# DeKalb County Government

**File #:** 2019-4075  
**File Status:** Preliminary Item

**Application of Georgia General Snapfinger Dev c/o Battle Law to rezone property from R-100 (Residential Medium Lot-100) to MR-1 (Medium Density Residential-1) for a mixed residential development consisting of 132 single-family attached townhomes and 24 single-family detached homes at a density of 9.05 units per acre, at Kelley Chapel Road and Snapfinger Road.**

**STAFF ANALYSIS**

# Site Plan

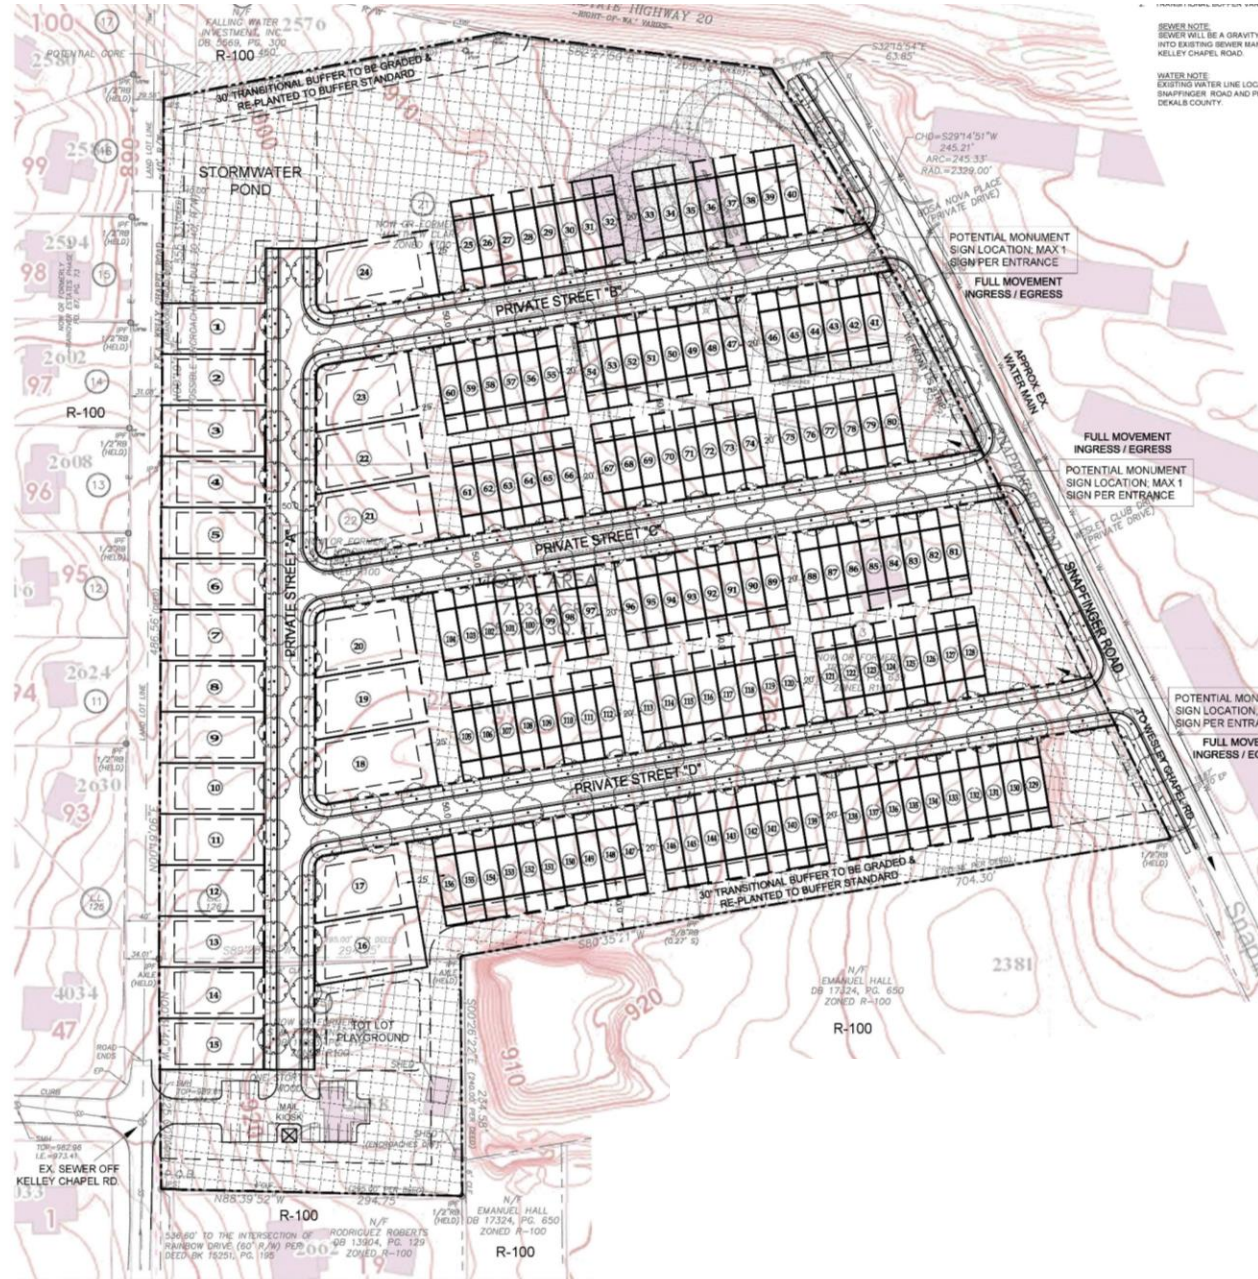
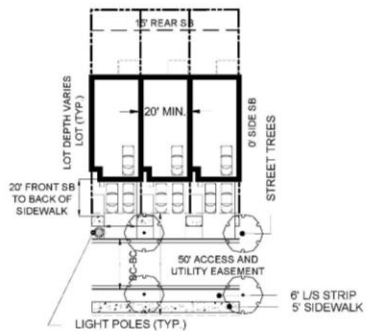
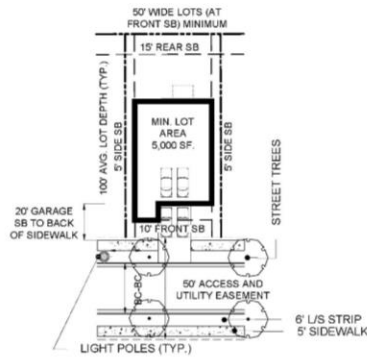
The site is densely wooded. Although the site plan indicates the footprints of homes on two of the four parcels that comprise the site, the County's aerial photographs indicate that these homes have been demolished or partially destroyed.

The proposal under consideration is for 132 single-family attached (townhome) units and 24 single-family detached homes with a density of 9.05 units per acre. Vehicular access would be provided from the Kelley Chapel Road stub and at three points on Snapfinger Road. The single-family lots would be located on the west side of the site, on the side of the site that is closest to the single-family residential lots of the Rainover Estates subdivision. The townhomes are laid out in rows along 560- to 600- foot long blocks in buildings of six to ten units each. Each townhome unit would have a front-entry, two-car garage. Areas to be used for rear yards are delineated. Strips of common area, approximately 12 feet wide, run between the rear yards.

The site plan shows that the wooded area at the north end of the site, next to I-20, would remain undeveloped. A "tot lot" playground which appears to be approximately 80 square feet, is shown near the Kelley Chapel Road entrance to the development. A mail kiosk is also located near this entrance.

<b>MR – 1 STANDARD</b>	<b>REQUIRED/ALLOWED</b>	<b>PROVIDED/PROPOSED</b>	<b>COMPLIANCE</b>
MAX. D.U.s/ACRE (BASE, W/BONUSES)	Base: 8 d.u.s/acre W/Bonuses: 12 d.u.s/ac.	9.05	
DENSITY BONUSES	Public improvements, transit proximity, non-residential uses, amenity proximity	Information not provided.	Information not provided.
MIN. OPEN SPACE /ENHANCED OPEN SPACE (Applicable if project is > 5 ac. or ≥ 36 d.u.s)	Open space: min. 20% of total site acreage = 3.44 ac. Enhanced O.S.: min. 10% of total site acreage = 15,019 s.f.	Information not provided. “Tot lot” – approximately 80 square feet	Information not provided. Variance required for enhanced open space
MIN. TRANSITIONAL BUFFER	30-foot buffer along north and south property lines	30-foot buffer along north and south property lines	Yes
MIN. LOT AREA	S-F detached: 5,000 s.f.	5,000 s.f.	Yes
MIN. LOT WIDTH	S-F detached: 50 feet	50 feet	Yes
MIN LOT DEPTH- NEW CORNER LOT	65 feet	90 – 124 ft.	Yes

MAX. LOT COVERAGE – S-F LOTS	50%	Information not provided	Information not provided
MAX. LOT COVERAGE –TOTAL ACREAGE OF TOWNHOME PORTION	70%	Information not provided	Information not provided
<b>BUILDING SETBACKS</b>	FRONT (Town Center)	S-F detached: determined by ROW and streetscape (min. 10 ft.) S-F attached: Not applicable	10 ft. Yes
	INTERIOR SIDE	S-F detached: 3 ft. w/min. 10 ft. separation between bldgs. S-F attached: Not applicable	5 ft. for each lot (10 ft. separation) Yes
	SIDE – CORNER LOT	S-F detached: 10 ft. S-F attached: Not applicable	10 ft. Yes
	REAR W/O ALLEY	S-F detached: 20 ft. S-F attached: Not applicable	15 ft. Setbacks must comply or variances must be approved.

MINIMUM UNIT SIZE	S-F detached: 1,200 s.f. S-F attached: 1,200 s.f.	Information not provided.	Information not provided.
MAX. BLDG. HEIGHT	S-F detached: 35 ft. S-F attached: 3 stories or 45 ft.	2 stories or 35 ft. 2 stories or 35 ft.	Yes Yes
PARKING	S-F detached: Min. 2/unit; Max. 4/unit  S-F attached: min. 1.5/unit + .25 guest pkng.; max. 3/unit + .25 guest pkng.	S-F detached: 2 garage, 2 driveway  S-F attached: 1 garage, 2 driveway  19 spaces at mail kiosk	S-F detached: Yes  S-F attached: Variance required to reduce guest parking
MIN. STREETSCAPE DIMENSIONS - PRIVATE DRIVES	5-ft. landscape strip and 5-ft. sidewalk on each side; street trees every other unit, or separation of peds & autos	6-ft. landscape strip and 5-ft. sidewalk on each side; street trees every 50 ft.	Variance required for street tree spacing

N8. [Based on site plan dated 7/18/19] Coordination with GDOT's MMIP projects along I-20 required prior to permitting. Coordination with MARTA I-20 east line required prior to permitting. Bring Snapfinger Road along property frontage down to apartment driveway (Wesley Club Drive) up to current county standards (24 pavement, header curb, 5-foot sidewalk, landscape strip, and street lights. Add Street Lights at entrance on Kelly Chapel Road.
